## TAKOMA JUNCTION

### Description

No. MR2021019, 120190150,  
820190090

Completed: 1.7.2022

Figure 1: Applicant proposed truck turning movements for WB-67 truck, Source: NDC letter to SHA dated July 14, 2021

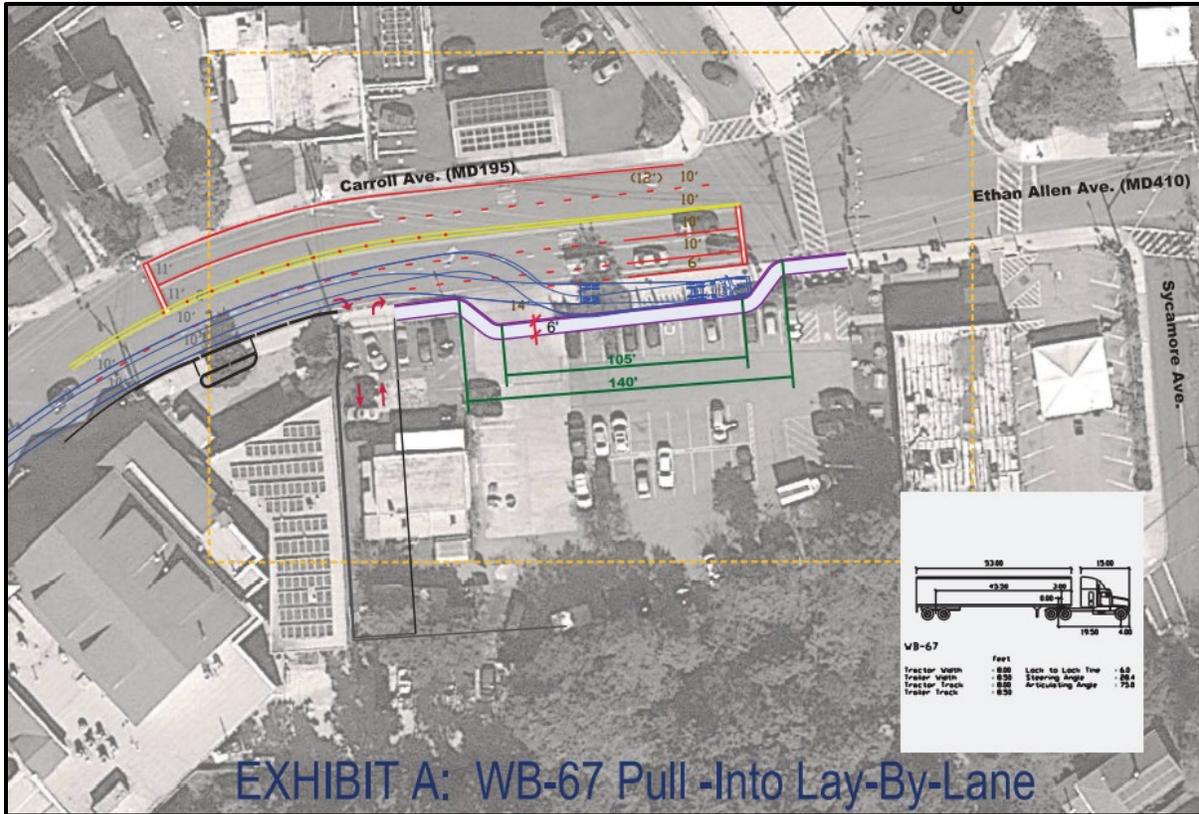
The proposed layby would be located along the Site frontage on Carroll Avenue, which would partially encroach into the public right-of-way. The latest MDOT SHA letter states that while the Applicant has increased the width of the layby (see Figure 1 below), based on the turning movements necessary for a WB-67 (18-wheeler truck), the truck would encroach into the left lane as well as the bicycle lane in order to access the layby, creating an unsafe condition for both vehicles and bicyclists travelling eastbound along Carroll Avenue.

Figure 2: Applicant proposed truck turning movements for SU-30 truck, Source: NDC letter to SHA dated July 14, 2021

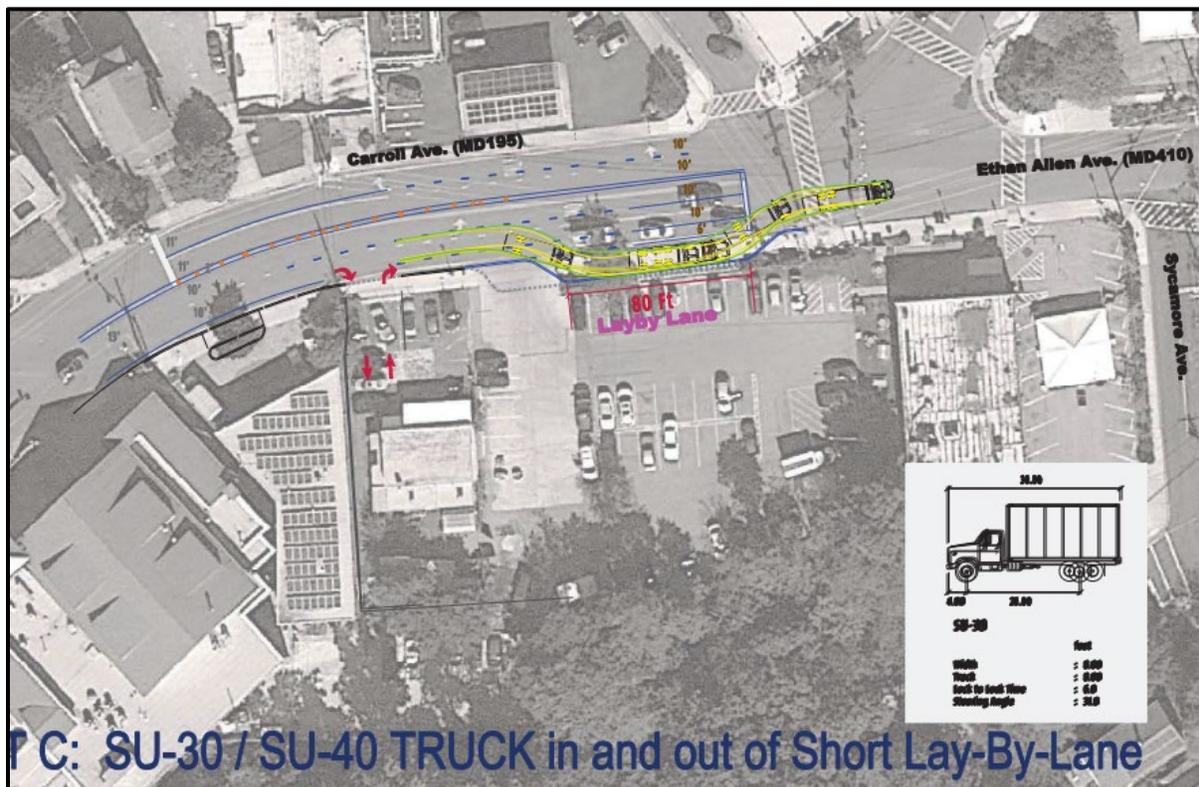
The Applicant also provided MDOT SHA an alternative layby option (shown in Figure 2 below) that would accommodate smaller, SU-30 trucks. MDOT SHA stated that while the smaller layby presented fewer potential conflicts and required fewer maneuvers to position the truck for loading activities, the layby remains inherently unsafe due to the crossing of the bicycle lane and proximity to the intersection. MDOT SHA was also skeptical that the Applicant, a private entity and not a regulatory agency, would be able to regulate or enforce limiting use of the layby to smaller trucks and if larger trucks were to make use of the layby, resulting in an unsafe condition. Additionally, the Applicant has not confirmed whether the Takoma Park Silver Spring (TPSS) Co-op would be amenable to utilizing only SU-30 trucks or smaller vehicles.
